***SYDNEY WATER CORPORATION  
MULGOA, WALLACIA & SILVERDALE  
SEWERAGE SCHEME***

**Director-General's Report  
Section 115C  
of the Environmental  
Planning and Assessment**

**June 2004**

Figure 2: The Revised Proposed Scheme

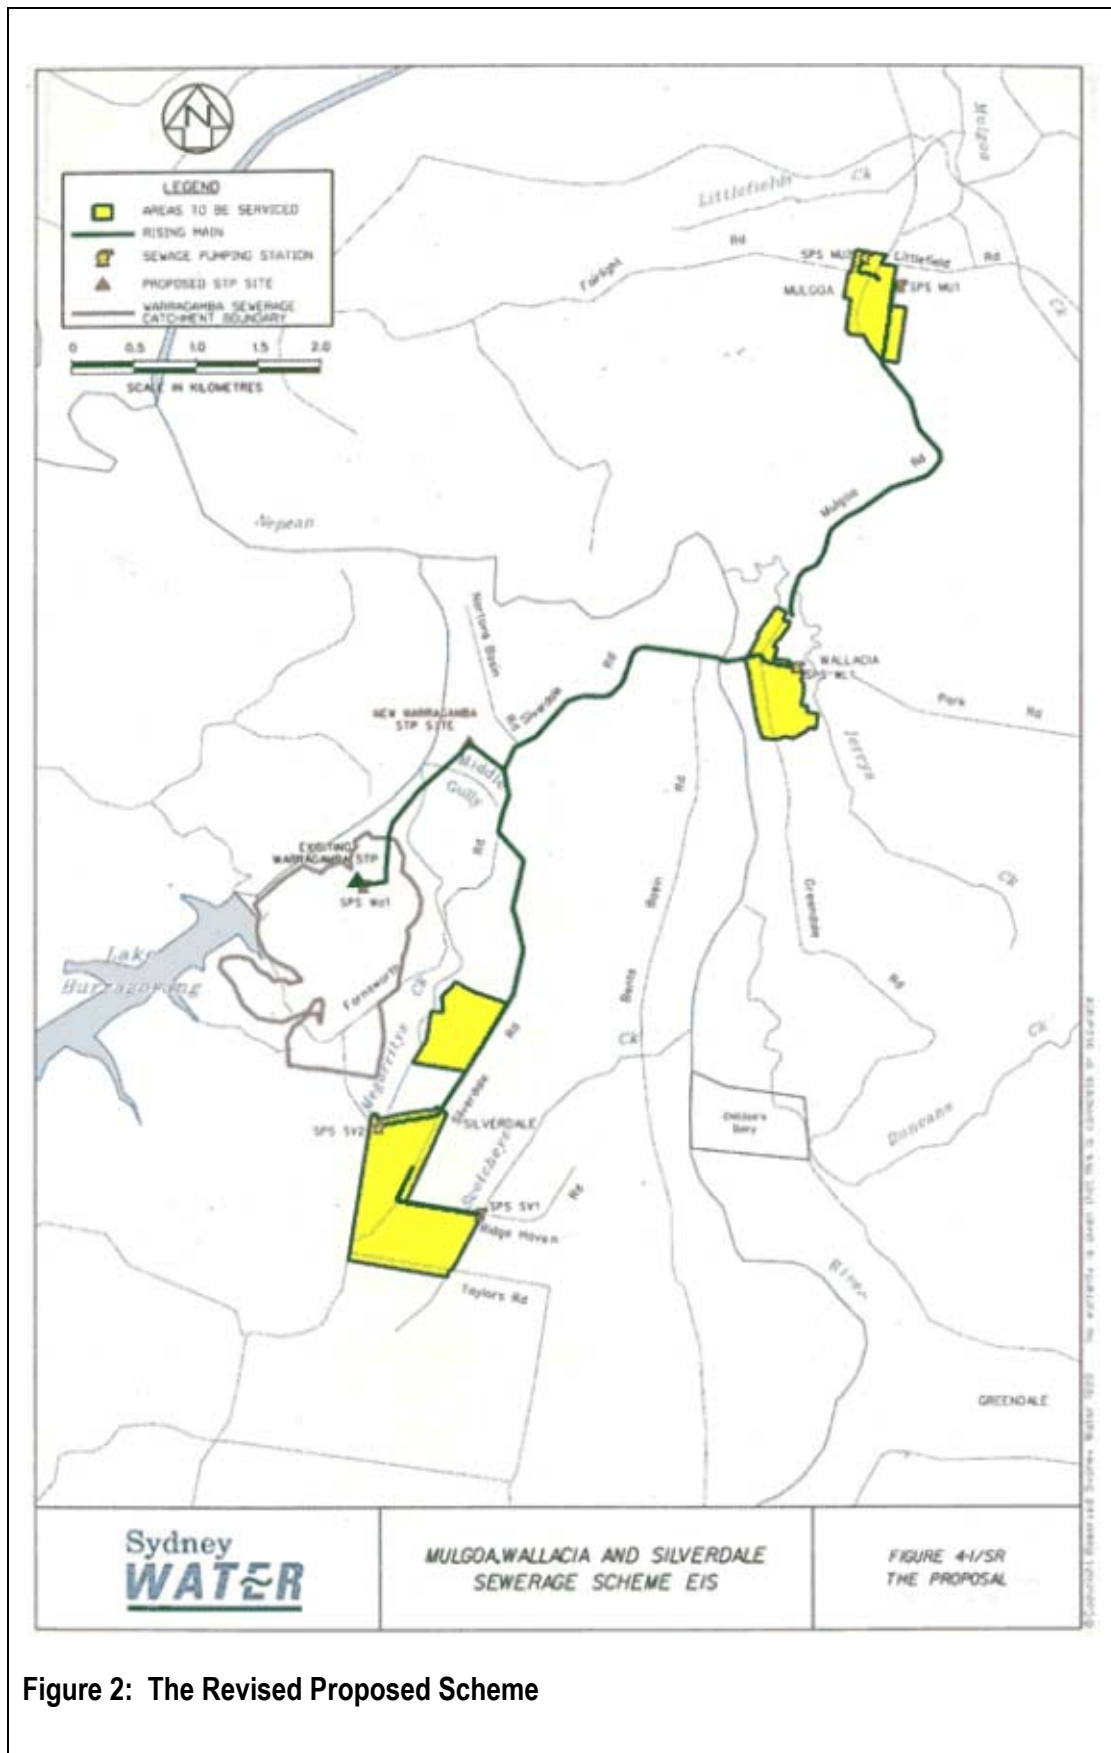
Figure 2 shows the revised scheme. Figures 4-6 show the sewer concept designs respectively for Mulgoa, Wallacia and Silverdale.
